Customer information Nr. 001-2023

ALL BCC 230V and 115V
ALL BOX 30 230V and 115V
ALL WAVE 30 230V and 115V

DETAILS: Change of carbonator bowl 0,5 LT code 130010

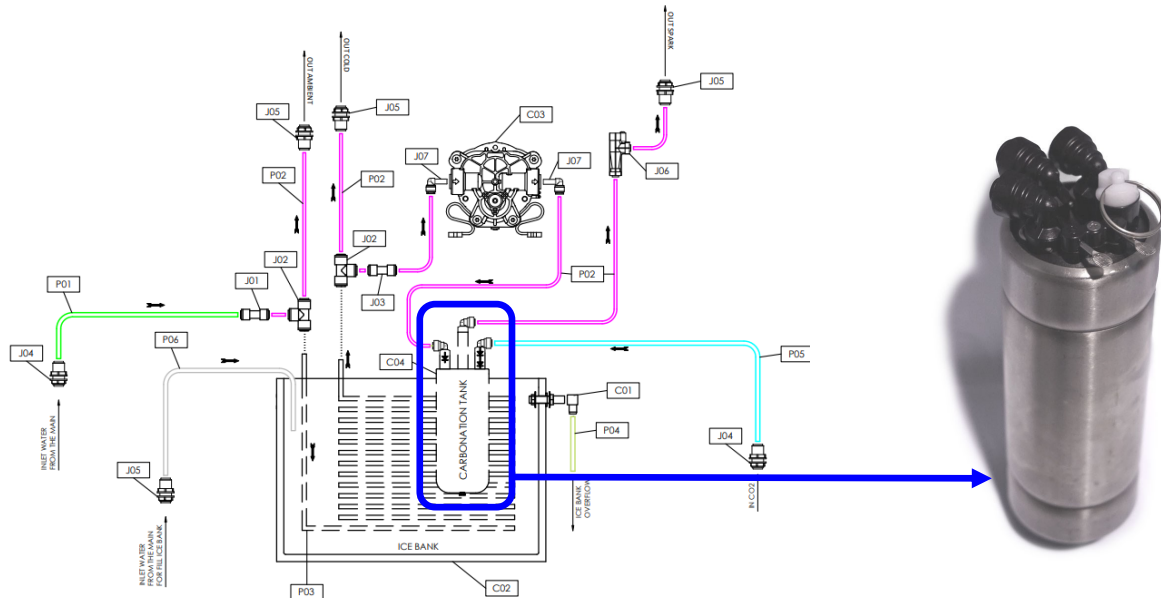
REASON: Technical improvement for the function of the sparkling water system working with 0,5 LT carbonator bowl.

CHANGES PROPOSAL: Upgrade to a new carbonator bowl with a inlet water injection of 1,25 mm which increases the inlet flow rate.

Spare parts list changes with new part number code 130261
